Value Engineering Study Report

EDS-545(40), BRN-014-1(73)(74) McDuffie County

SR 17 from SR 43 to West of SR 6

May 4, 2007

R-1

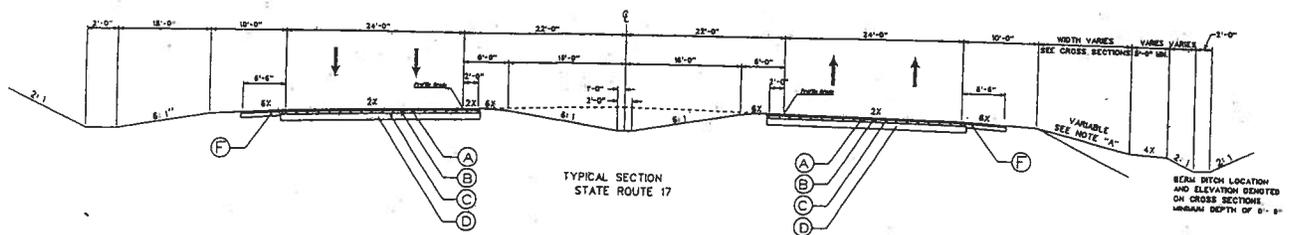
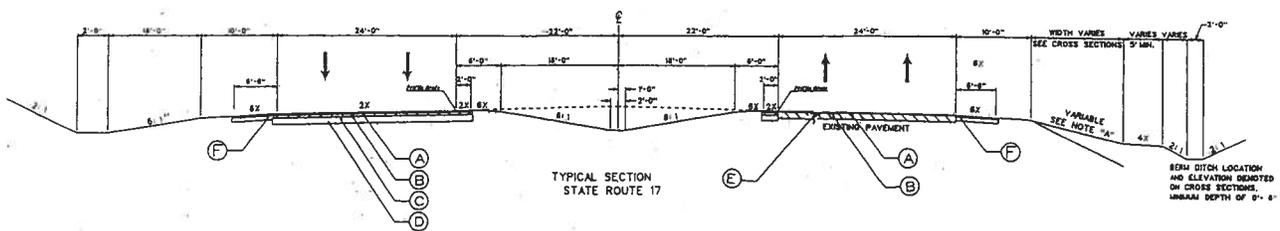
DESCRIPTION: **RE-EVALUATE EXISTING PAVEMENT ANALYSIS AND IF APPROPRIATE, UTILIZE THE EXISTING PAVEMENT AND PROFILE AS IS, UPGRADE PAVEMENT TO MEET STRUCTURE OR SURFACING REQUIREMENTS.**

GEORGIA DEPARTMENT OF TRANSPORTATION PROJECT: EDS-545(40), BRN-014-1(73)(74) McDuffie County - P.I. No.: 222250, 227815, 227816, SR 17 from SR 43 to West of SR 6	ALTERNATIVE NO.: R-7
DESCRIPTION: RETAIN EXISTING C.R. 6/SMITH MILL ROAD ALIGNMENT	SHEET NO.: 1 of 5

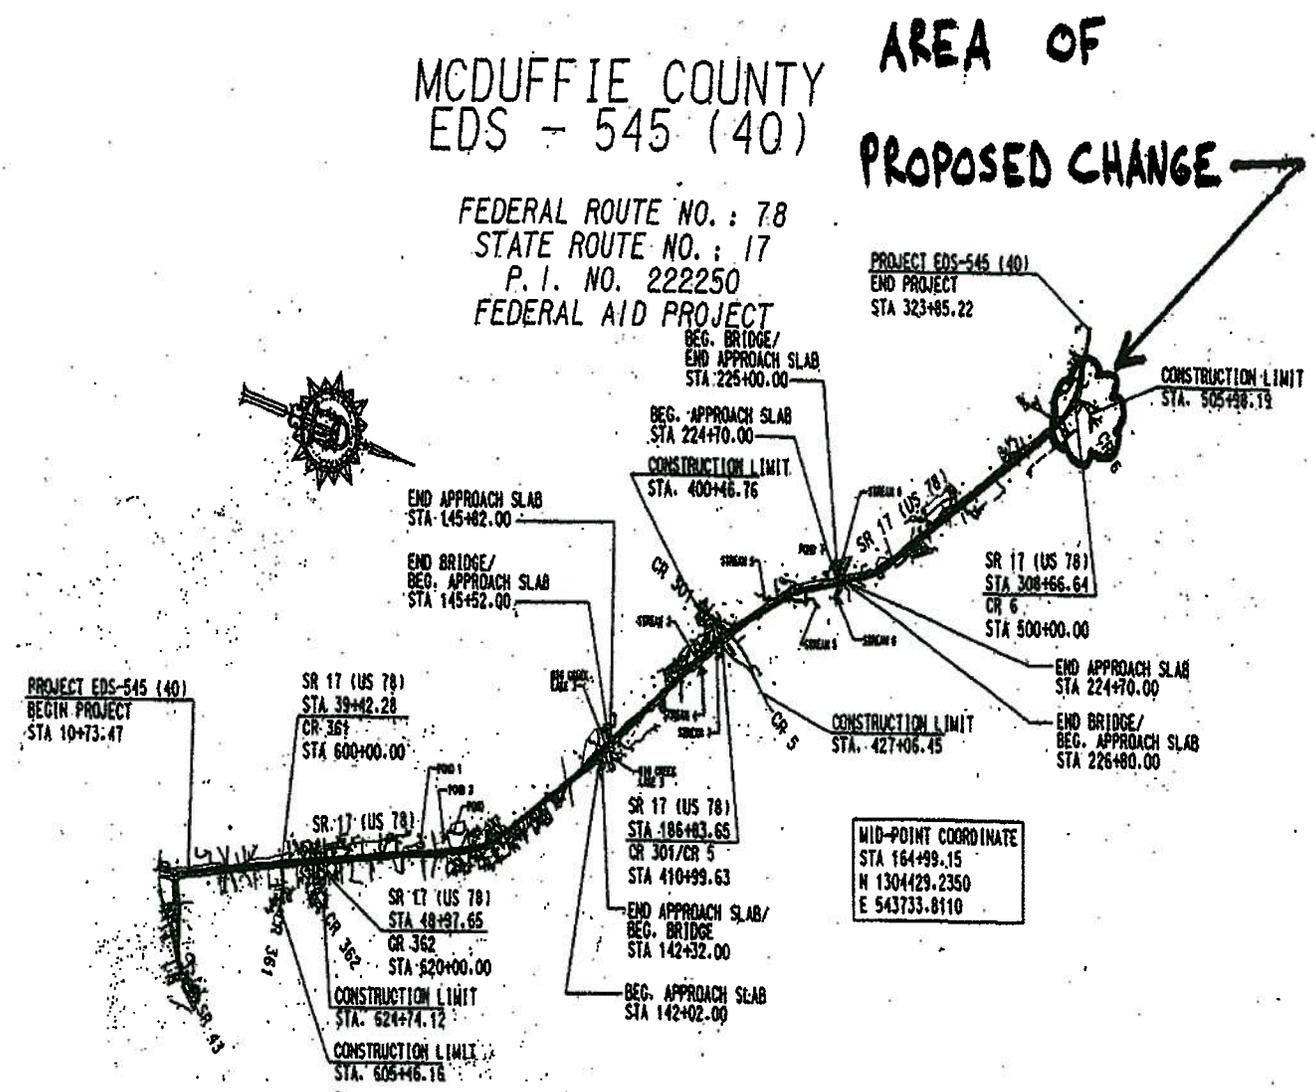
The original design realigns C.R. 6/Smith Mill Road to improve the horizontal alignment and provide for a perpendicular intersection with S.R. 17.

The alternative reduces cost by minimizing required improvements to a low volume side road. The proposed improvements to the horizontal alignment of C.R. 6/Smith Mill Road are excessive and only a minimum length tie-in is required to provide access to proposed S.R. 17. The proposed S.R. 17 roadway profile indicates that the existing C.R. 6/Smith Road tie-in is approximately the same elevation as the mainline. Therefore, it is recommended that the C.R. 6/Smith Mill Road tie-in be maintained on existing alignment and paved only to the limits of the S.R. 17 right-of-way. An analysis of the S.R. 17 profile indicates that this solution will provide adequate intersection sight distance will be provided per AASHTO requirements.

GEORGIA DEPARTMENT OF TRANSPORTATION PROJECT: EDS-545(40), BRN-014-1(73)(74) McDuffie County - P.I. No.: 222250, 227815, 227816, SR 17 from SR 43 to West of SR 6	ALTERNATIVE NO.: R-11
DESCRIPTION: RETAIN EXISTING C.R. 301 (RIDGE ROAD)/C.R.5 (RUSSELL'S LANDING ROAD) ALIGNMENT	SHEET NO.: 1 of 5

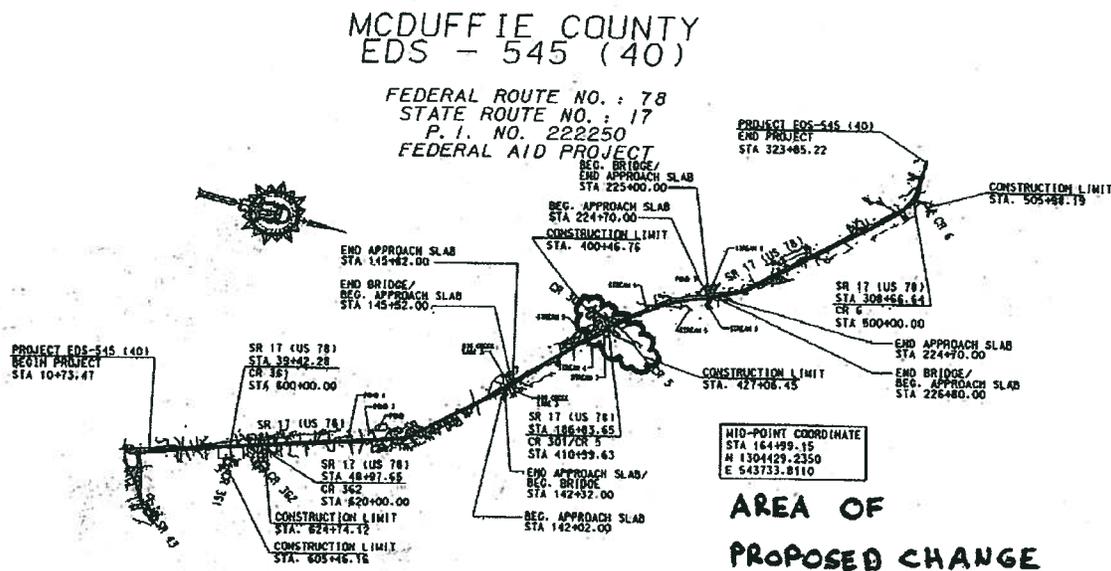
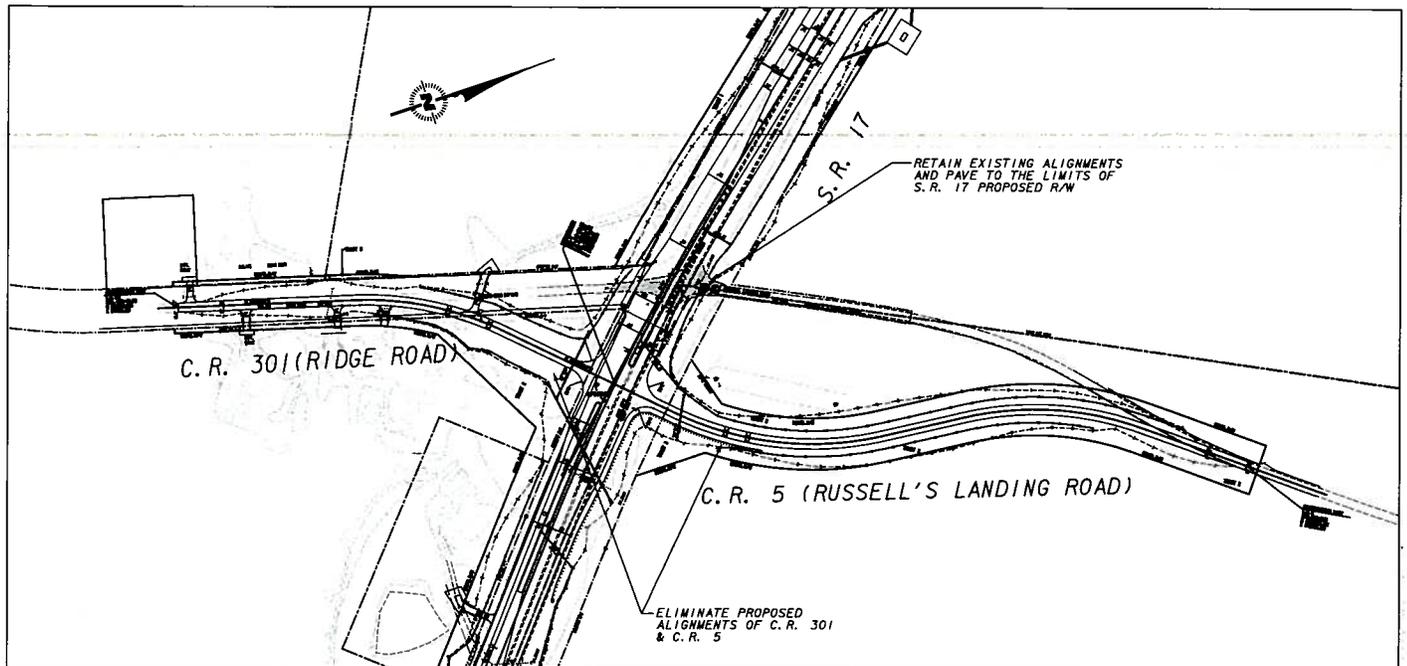
The original design realigns C.R. 301 (Ridge Road) and C.R. 5 (Russell's Landing Road) to improve the horizontal alignments and provide for a perpendicular intersection with S.R. 17.

The alternative reduces cost by minimizing required improvements to low volume side roads. The proposed improvements to the horizontal alignment of C.R. 301 (Ridge Road) and C.R. 5 (Russell's Landing Road) are excessive and only minimum length tie-ins are required to provide access from the side roads to proposed S.R. 17. The S.R. 17 roadway profile indicates that the existing C.R. 301 (Ridge Road)/C.R. 5 (Russell's Landing Road) tie-in is approximately one (1) foot lower than the mainline. Therefore, it is recommended that the tie-ins for C.R. 301 (Ridge Road) and C.R. 5 (Russell's Landing Road) be maintained on existing alignment and paved only to the limits of the S.R. 17 right-of-way. An analysis of the S.R. 17 profile indicates that this solution will provide adequate intersection sight distance per AASHTO requirements.

DESCRIPTION: Increase shoulder paving to full depth and add "V" gutter in lieu of
asphalt curb

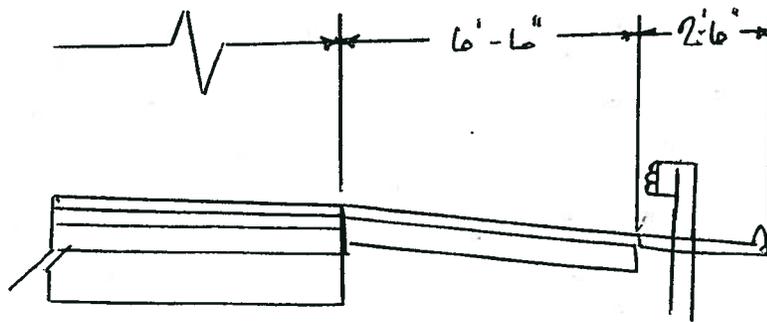
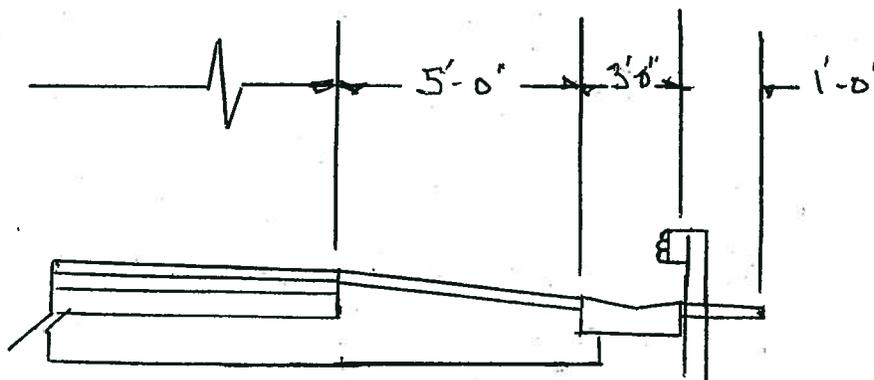
Original Design: Provides a full depth Roadway section of 21 ½" and a reduced section for shoulder paving in guardrail locations, the shoulder will be widened to accommodate the guardrail installation. Asphalt pavement will be installed for 2 ½' outside the paved shoulder beneath the guardrail per cost detail.
